ADDENDUM NO. 1

February 5, 2019

This Addendum supplements and amends the original Plans and Specifications and shall be taken into account in preparing proposals and shall become a part of the contract documents.

**MUSOM
BOILER AND CHILLER
REPLACEMENT**

DEMO/NEW WORK -
 FLOW DIAGRAMS
 & TEMPERATURE
 CONTROLS

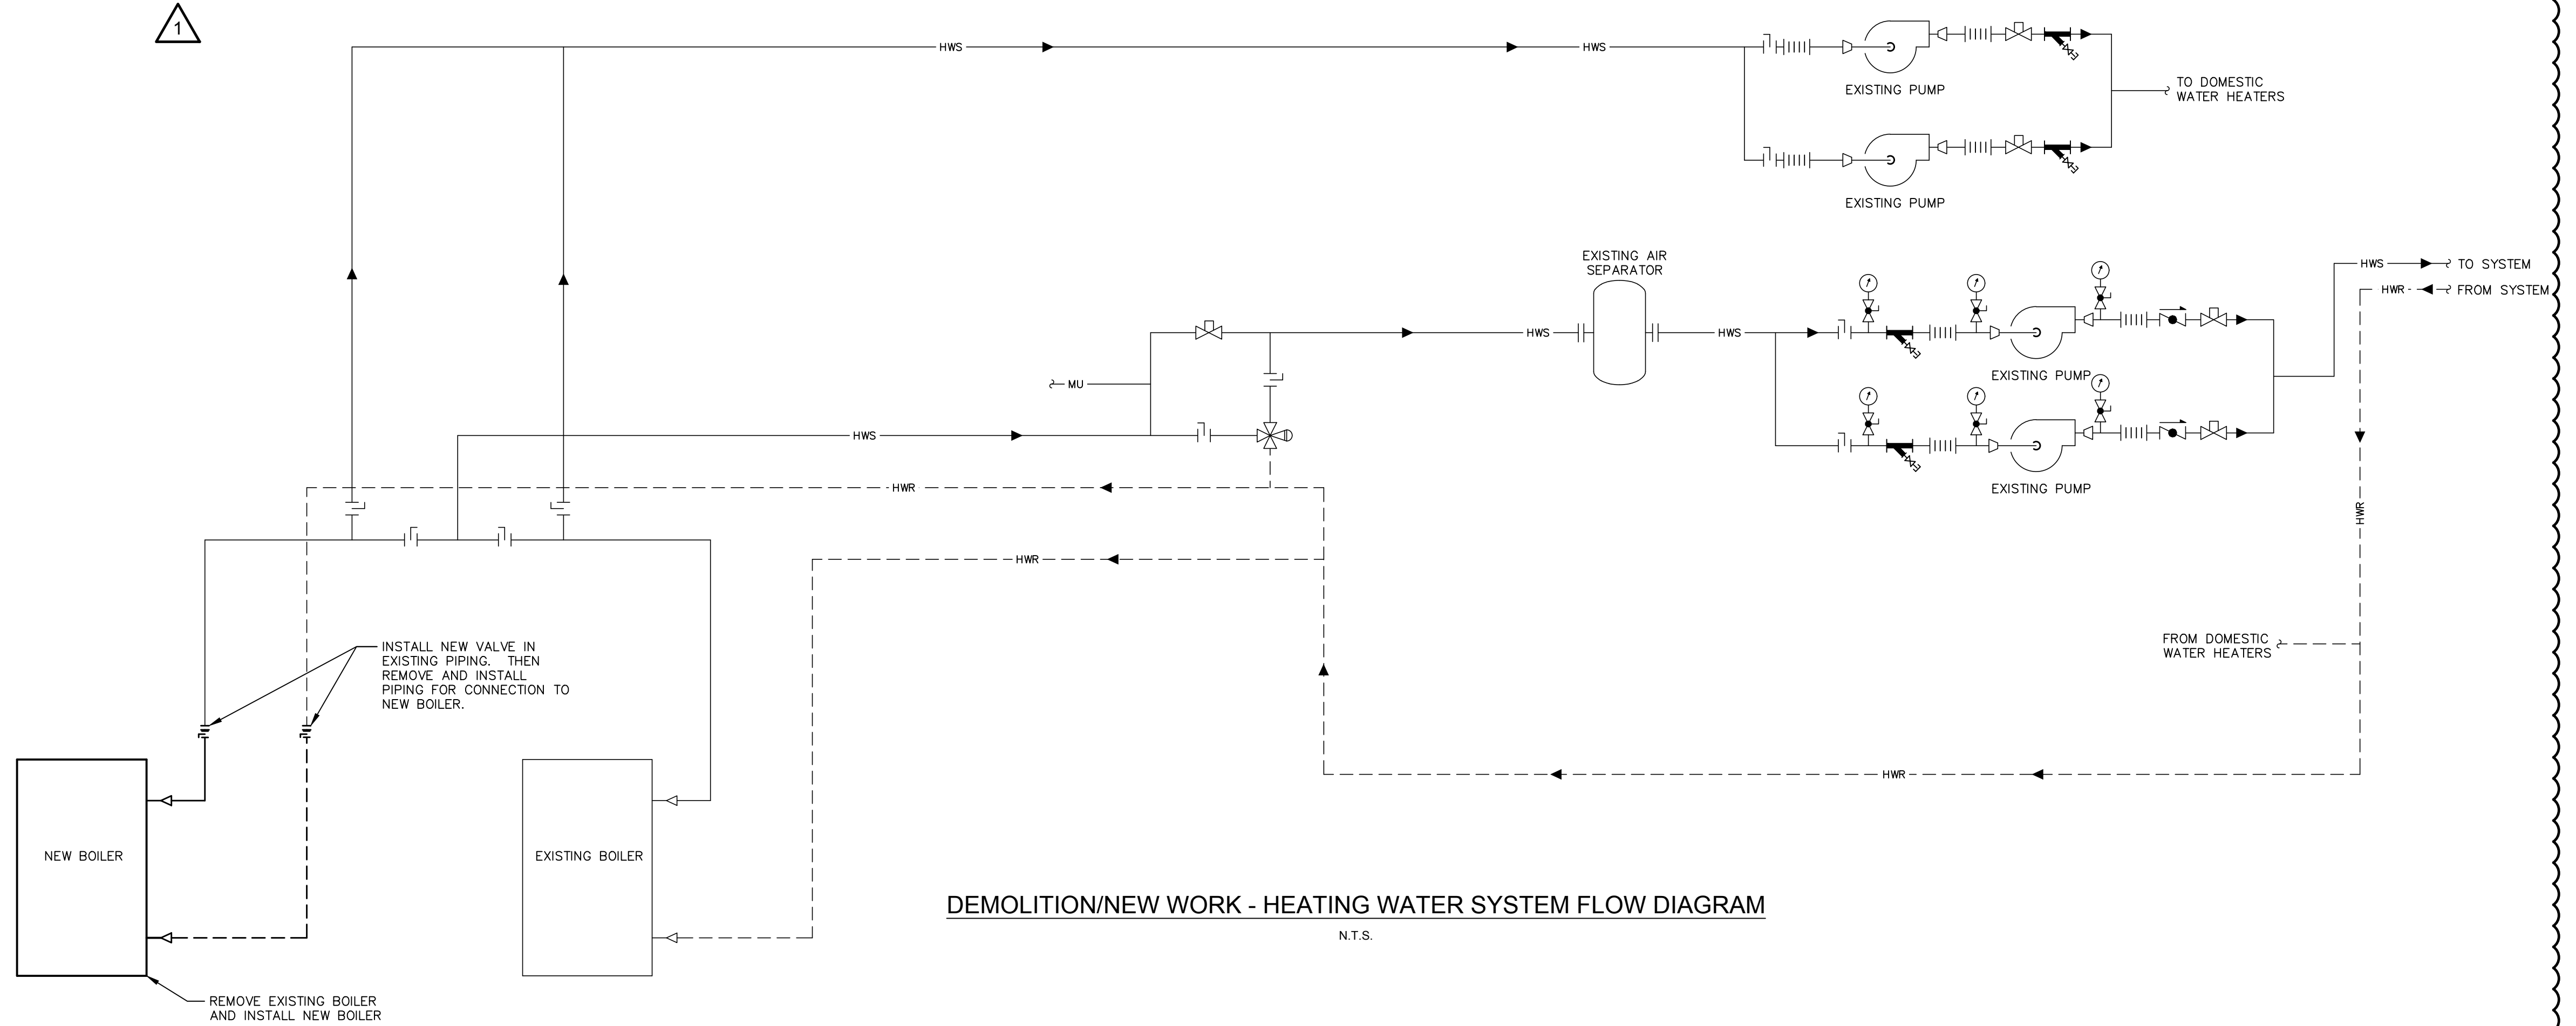
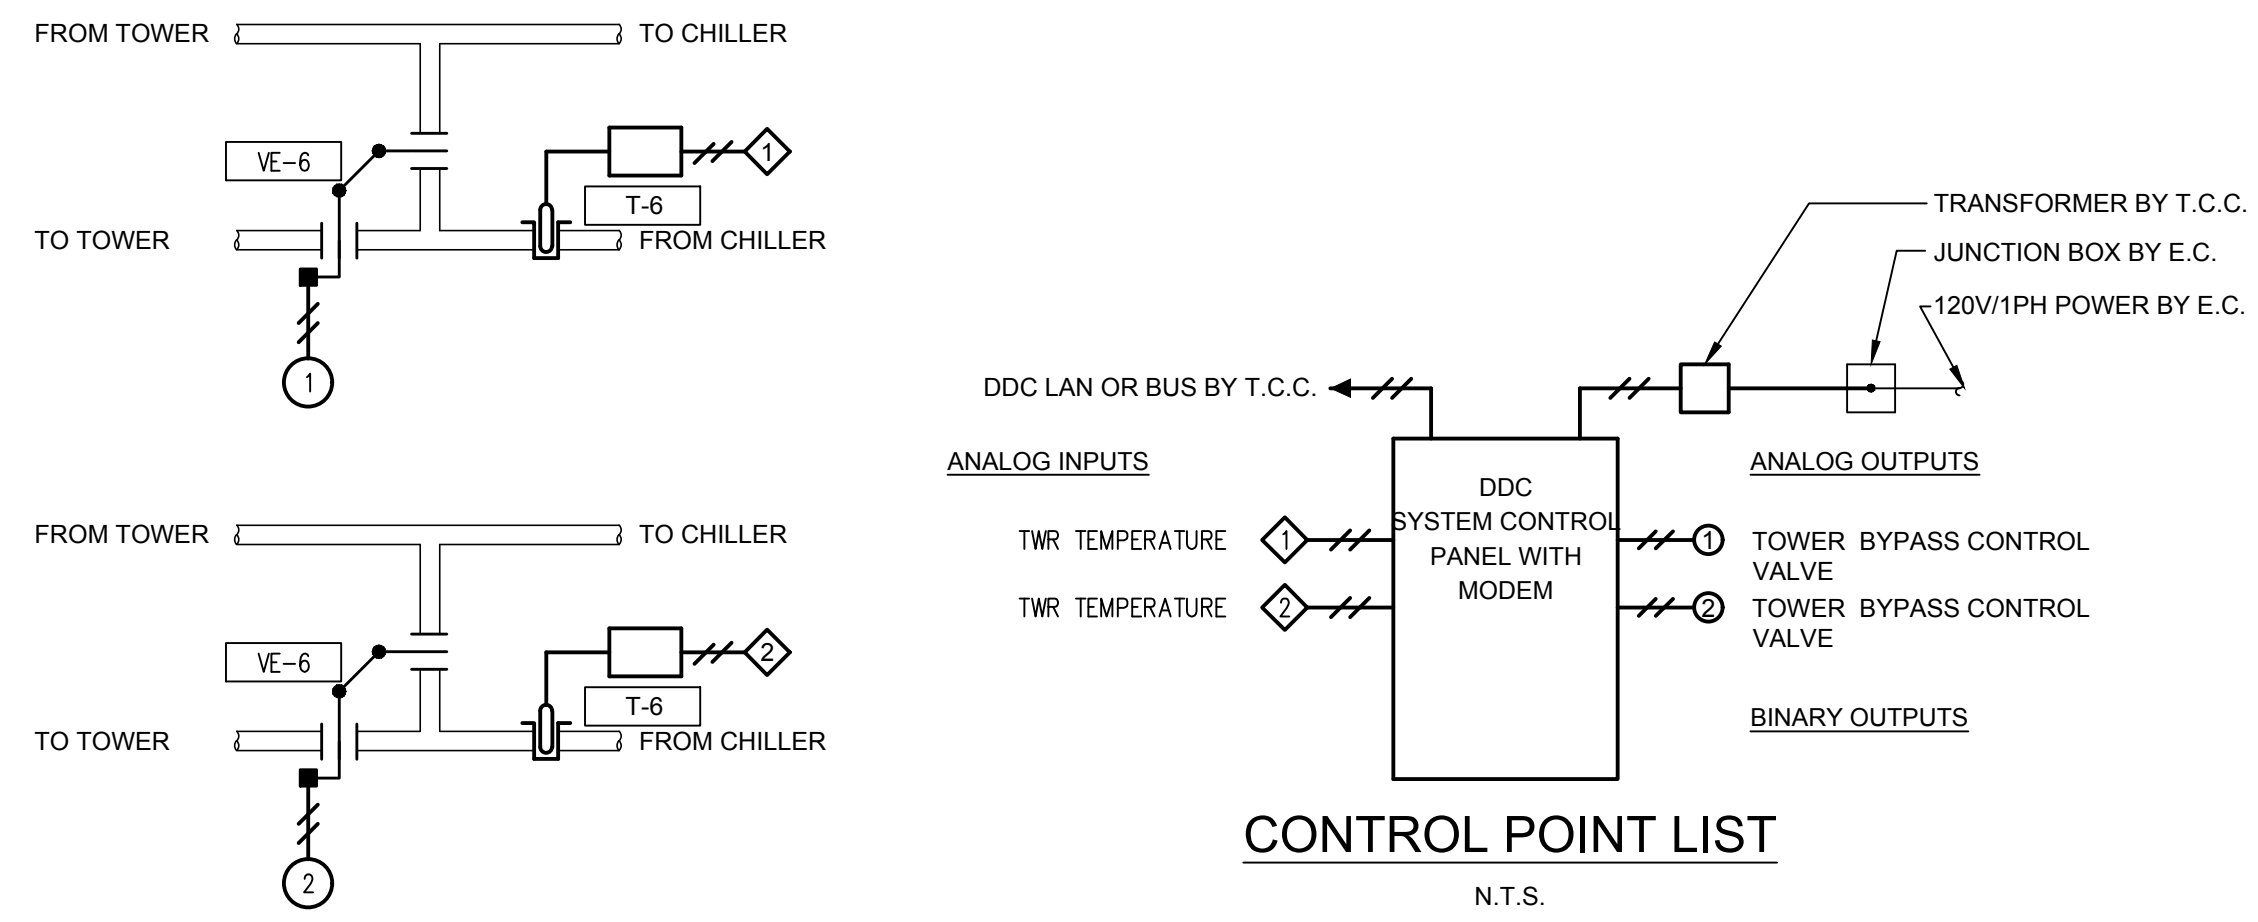
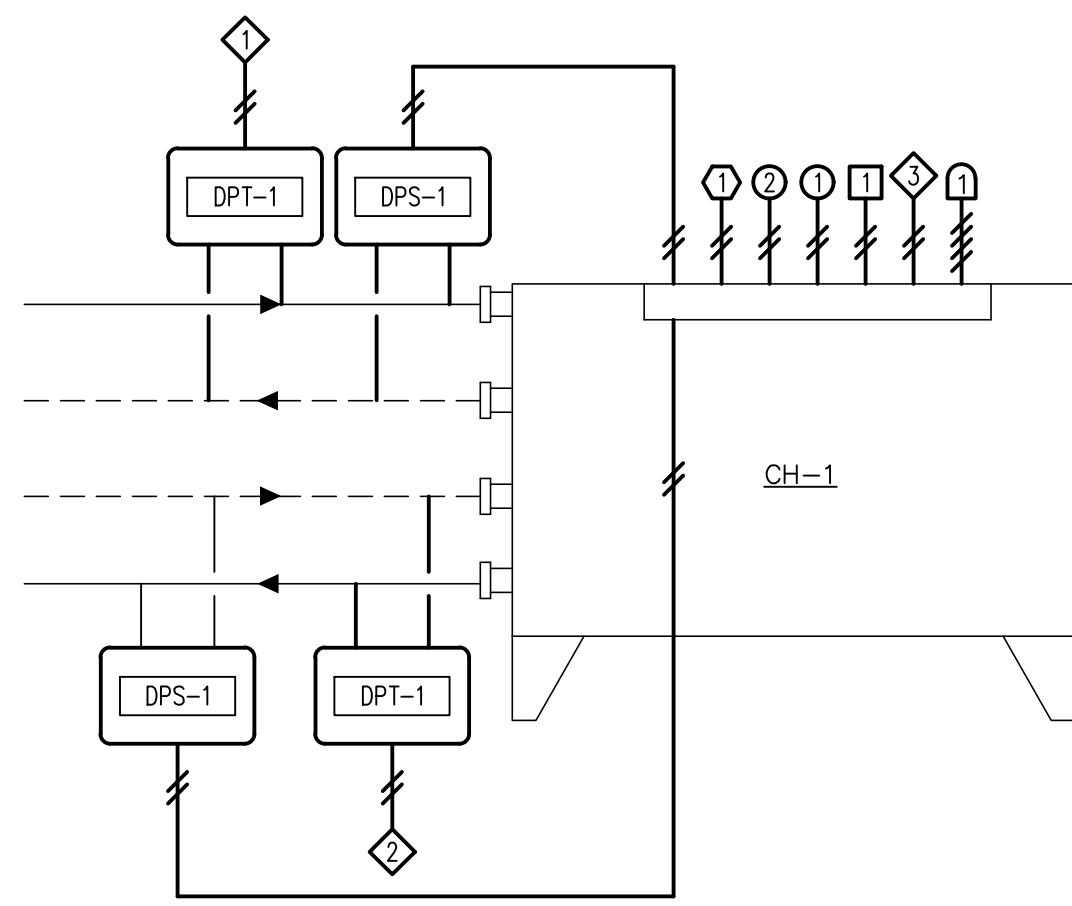
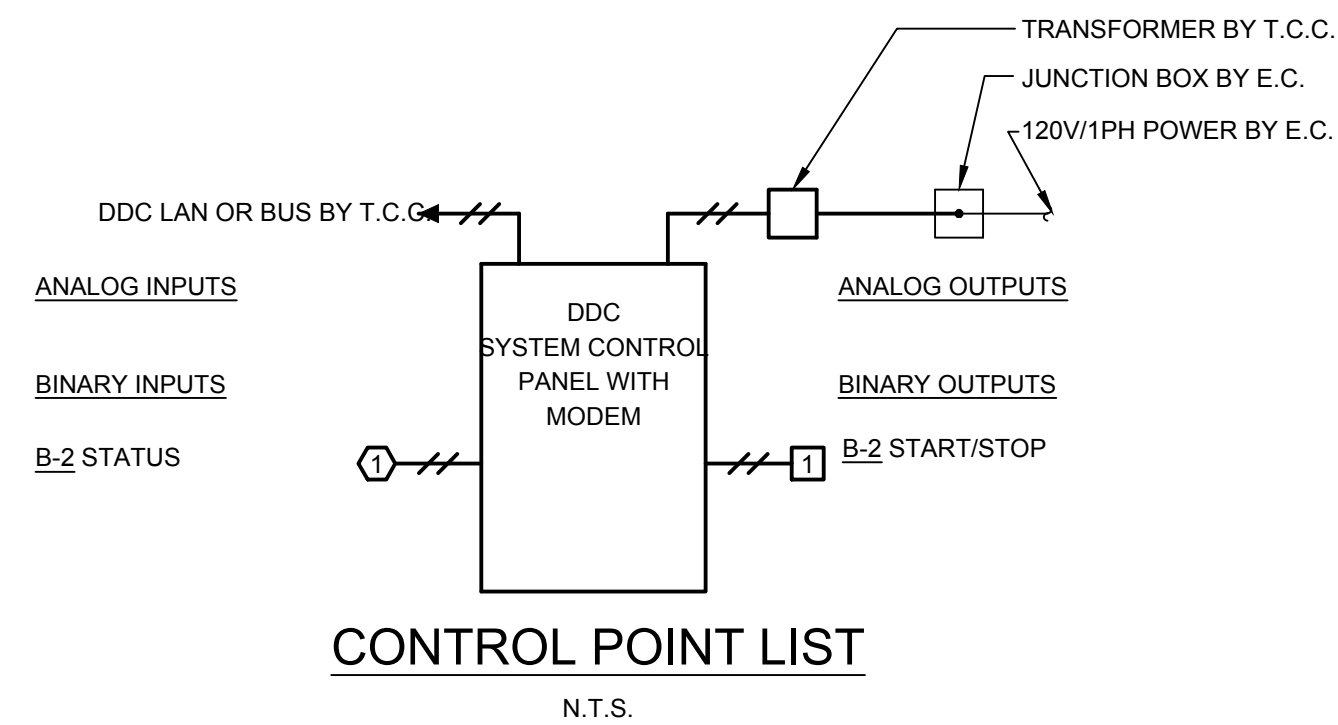
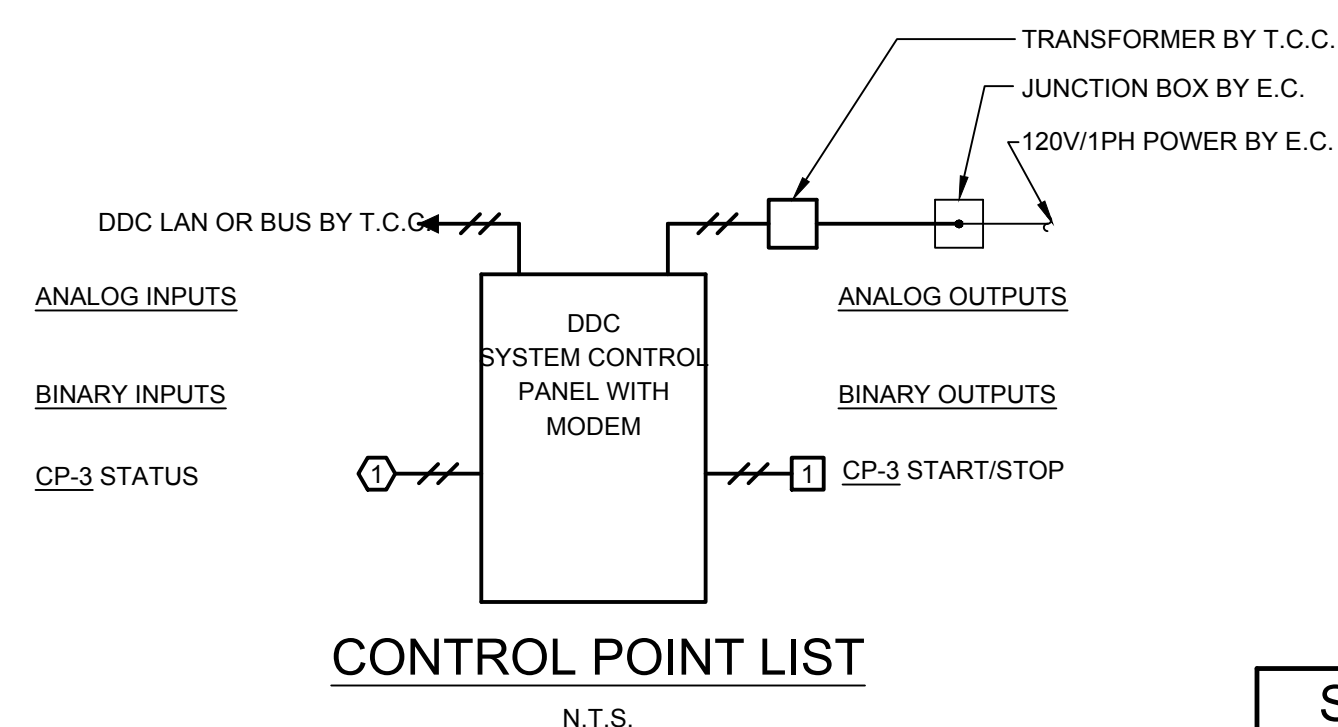
- Refer to attached sheet M3 for tower water cross connect piping to be installed under add alternate.
- ITEM 13 Sheet M4 "Demo/New Work – Flow Diagrams & Temperature Controls";

- Refer to attached sheet M4 for modifications to heating water system flow diagrams.
 - Refer to attached sheet M4 for addition of tower water pump, CP-3 control diagram.

- Refer to attached sheet M4 for modification of tower water bypass.

- Refer to attached sheet M4 for addition of general note in reference to controls manufacturer and devices.

JOHNSON CONTROLS ARE THE EXISTING CONTROLS IN THE BUILDING AND NO OTHER CONTROLS MANUFACTURER ARE ACCEPTABLE.
 CONTRACTOR SHALL BE RESPONSIBLE TO EXTEND ALL NEW TEMPERATURE CONTROLS INTO EXISTING PANELS. IF EXISTING PANELS ARE NOT AVAILABLE NEW PANELS SHALL BE PROVIDED. CONTRACTOR SHALL BE RESPONSIBLE FOR PROVIDING ALL NEW DEVICES, RELAYS, ETC. AS REQUIRED FOR INSTALLATION OF NEW CONTROLS TO MEET ALL SEQUENCE OF OPERATIONS. ALL PANELS, DEVICES, ETC. TO MEET MARSHALL UNIVERSITY STANDARDS.
